REVIEW OF THE DOE REPORT: "THE ORIGIN OF CALCITE-SILICA DEPOSITS AT TRENCH 14 AND BUSTED BUTTE AND METHODOLOGIES USED TO DETERMINE THEIR ORIGIN"

**SPECIAL REPORT No.18
CONTRACT No. 94/96.0003**

**SPECIAL REPORT Submitted to the
Nuclear Waste Project Office
State of Nevada**

November, 1994

Figure 1. Fission track ages of zircons from breccias at Busted Butte (top) and Trench #14 (bottom). From Levy and Naeser, 1991.

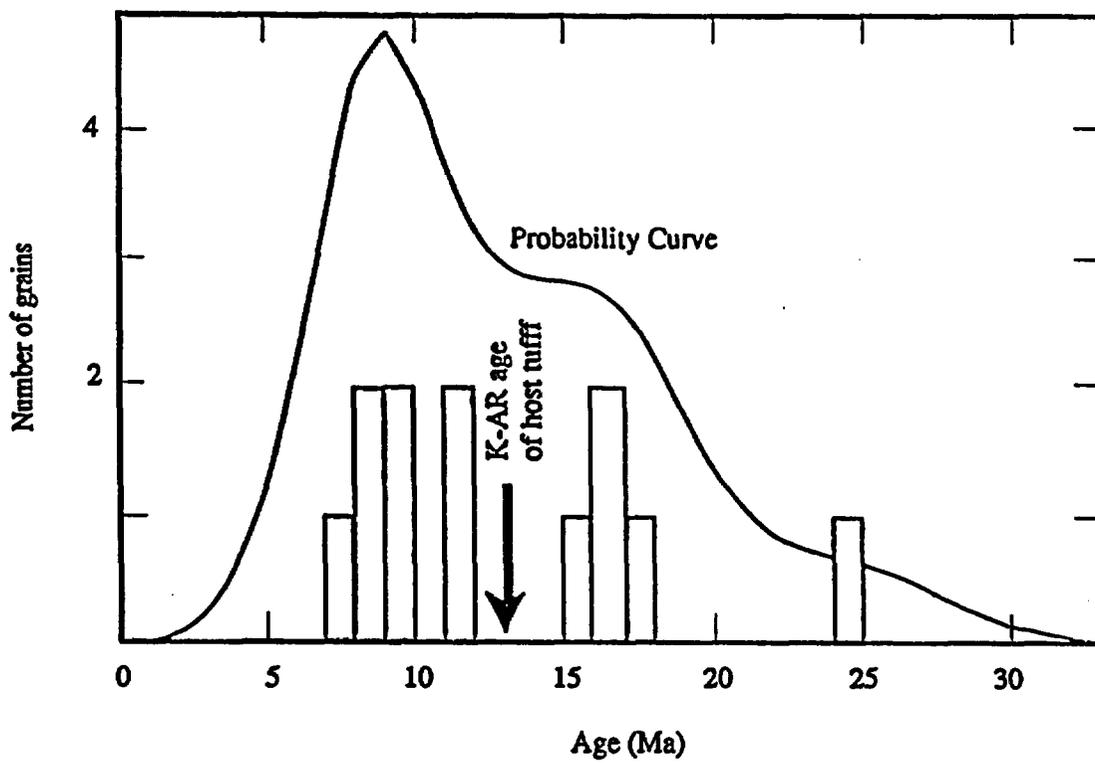
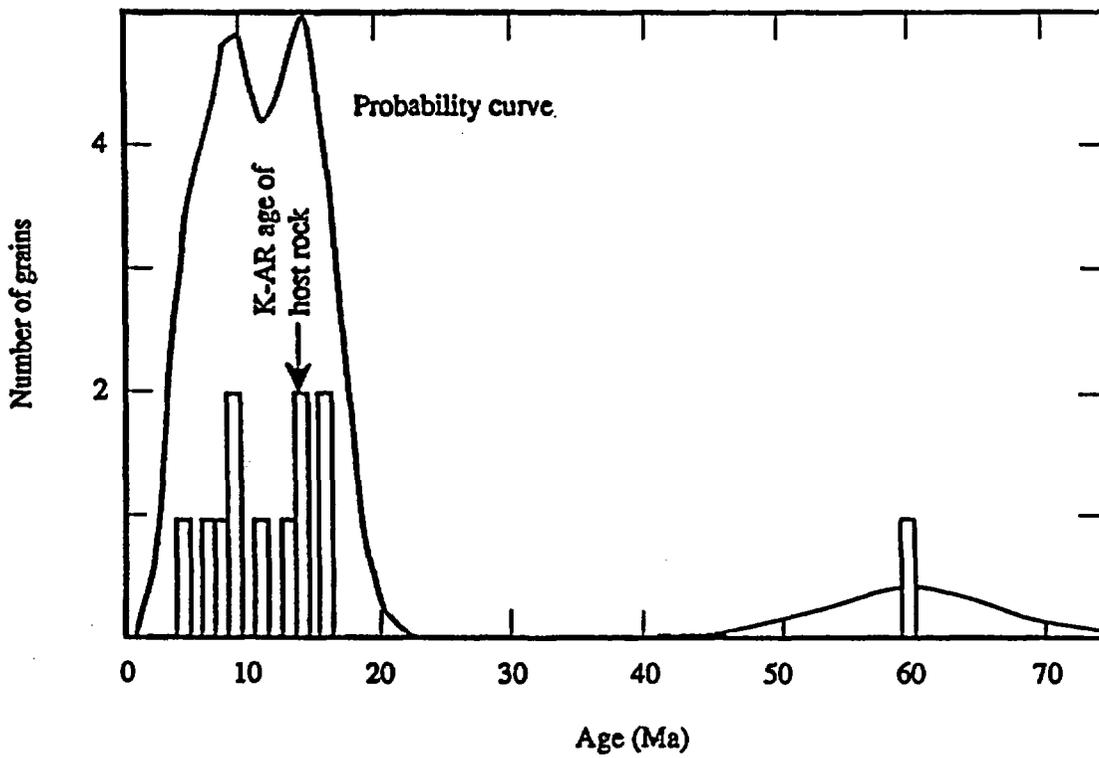
The data shown by Levy and Naeser in their Figures 7 and 8 are reproduced in the attached Figure 1. These data clearly show the multiple peaks identified by Levy and Naeser. *Contrary to what is stated by the Panel*, most of the zircon crystals analyzed from each sample show dates considerably less than the Potassium-Argon ages of the host tuff (13 Ma), rather than greater than the age of the tuff. Further, the Panel implies an age for the host tuff of 10-12 Ma, while it is clearly stated to be 13 Ma.

An examination of the age data, as given in Figure 1, shows that there are ages 4.8 Ma, 6.2 Ma, 7.5 Ma, and 7.7 Ma among the crystals in these two samples. There are

several additional dates near 8.5 Ma. The two sigma interval attached to the youngest age, of 4.8 Ma, is 2.5. Thus, there is very high confidence (over 90%) that the age of heating of this crystal was between 2.3 Ma and 7.3 Ma, with the highest probability for a specific age being 4.8 Ma. The same interpretation of confidence intervals applies to the other ages given. Clearly, characterizing these age data as being within the age range 10-12 Ma, given "analytical uncertainty," is incorrect. It is on this inaccurate basis that the Panel states that (p. 3):

Figure 2. Ages of Fluid Alterations at Yucca Mountain

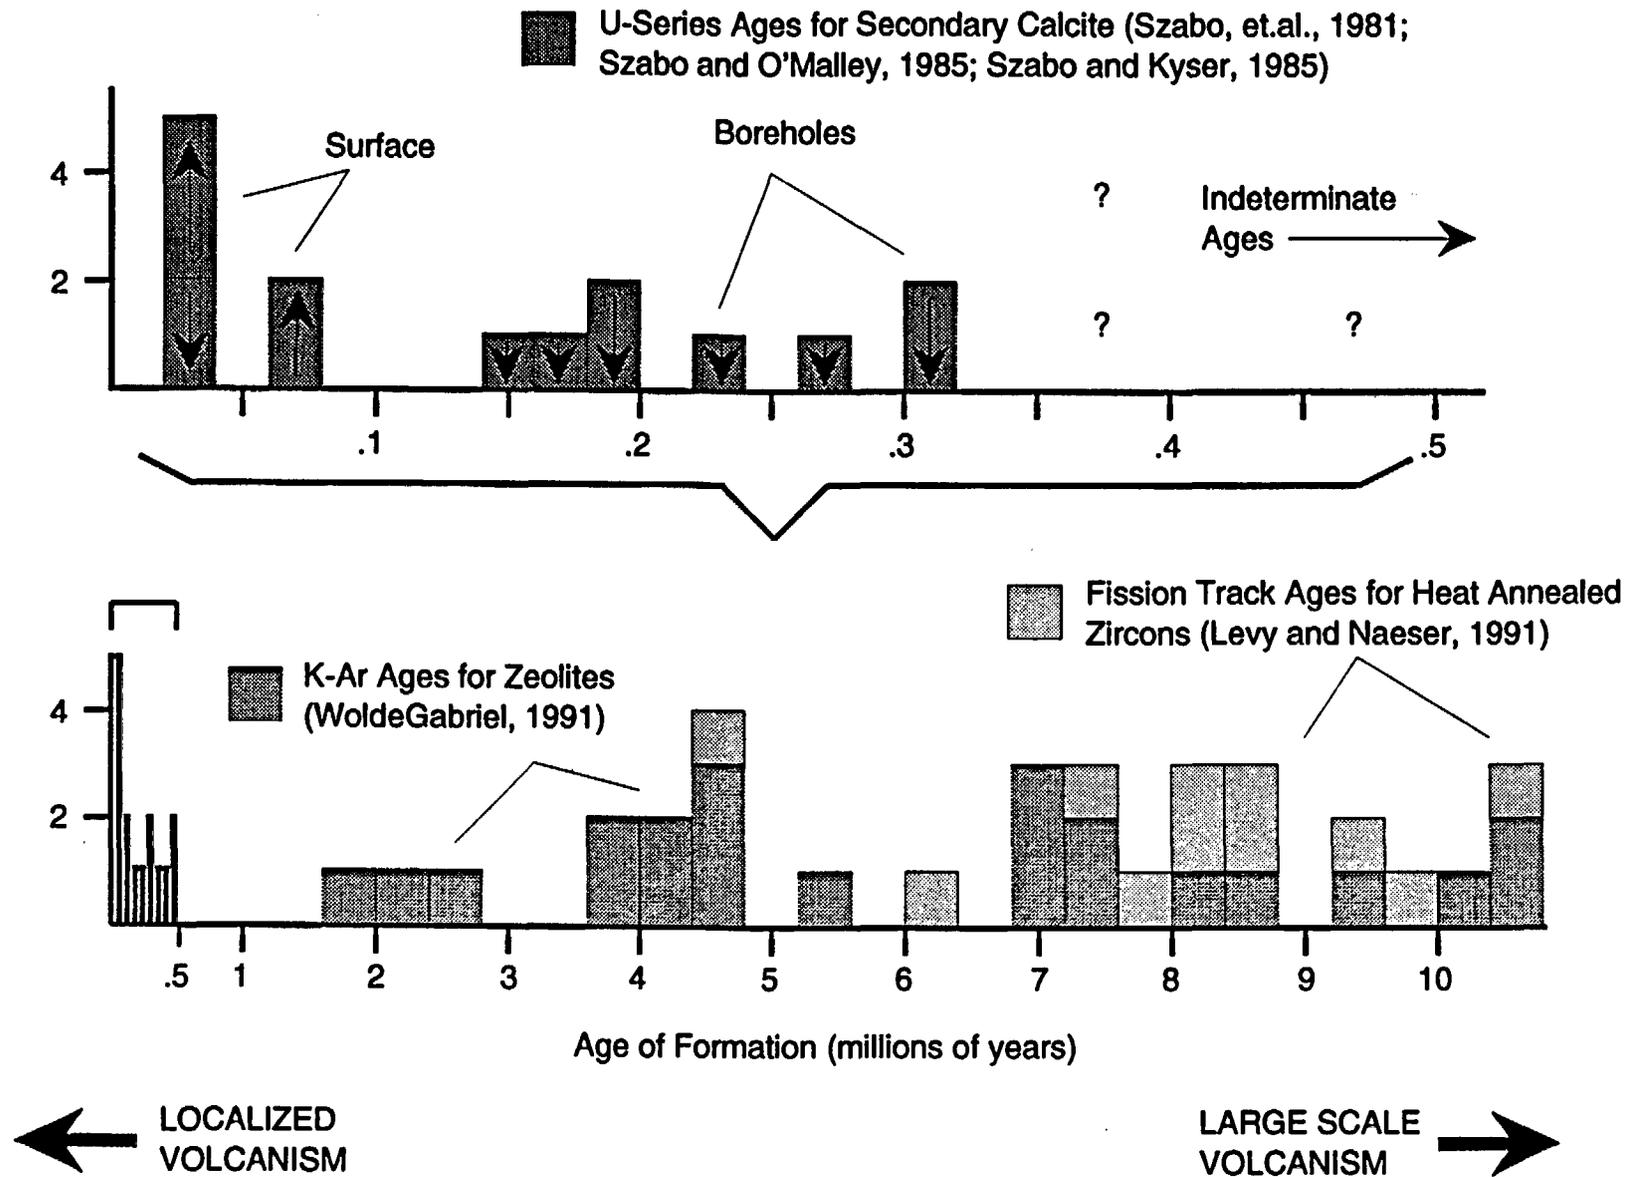
In regard to the latter, it is important to point out that the Panel did not mention that the K-Ar dates of the zeolites in question range from 2 to about 10 Ma, as shown in Figure 2, and are much younger than the host ignimbrites. Further, the youngest zeolites are near the surface and the oldest are at depths below the water table. If the water table reached its highest level at 12.8 - 11.6 Ma and receded downward from that

Figure 4. Borehole samples from Yucca Mountain reveal alteration products formed at high temperatures, indicating that the site has been invaded by high temperature fluids.

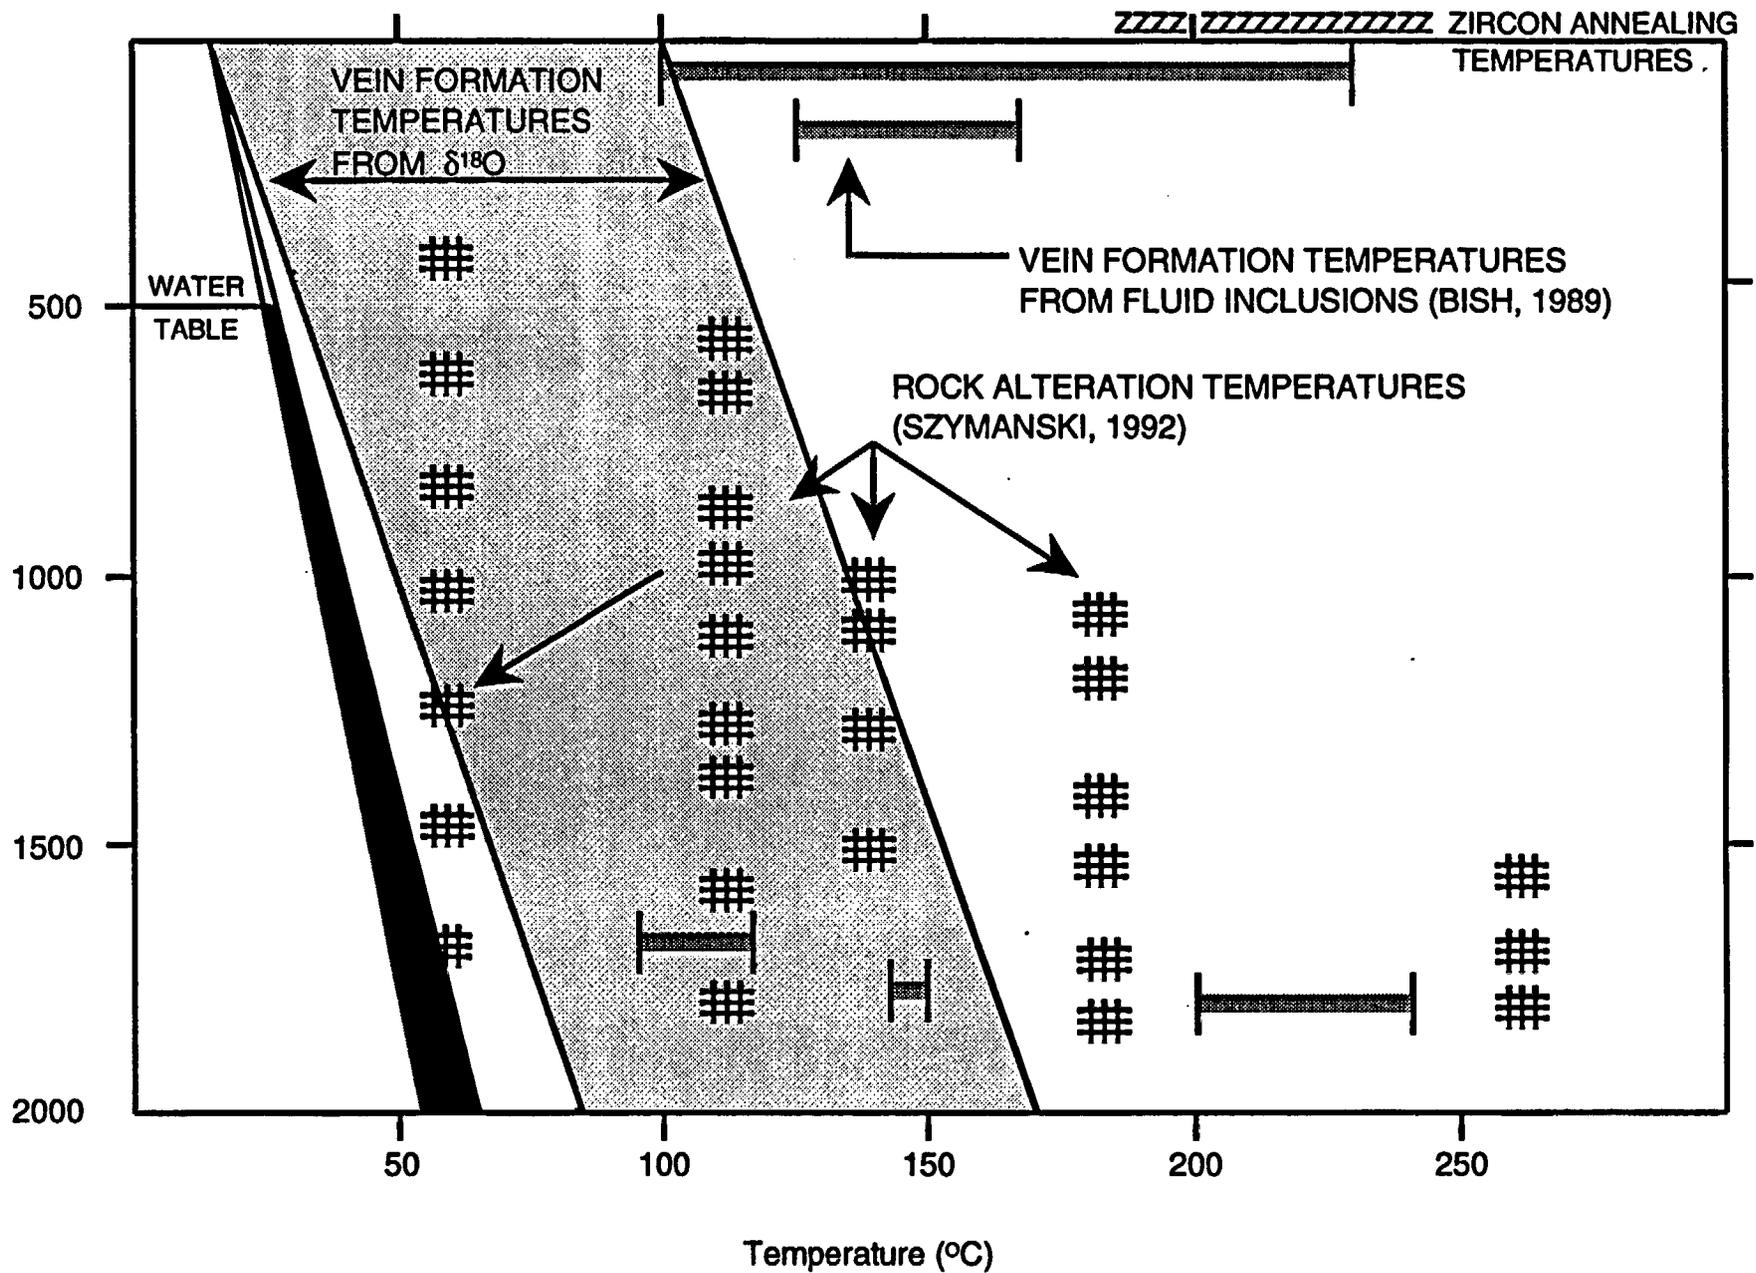
The fact that the Panel did not consider any of the data pertaining to paleo-temperatures and ignored all the age data, except that for the zircon ages which they misrepresented, has resulted in a description of the recent geologic and hydrologic history of the site that is almost certainly incorrect. Indeed, the only uncertainty that might still be entertained is whether the youngest ages, of less than 500 ka, are correlated with the high temperatures indicated in Figure 4. This can be cleared up
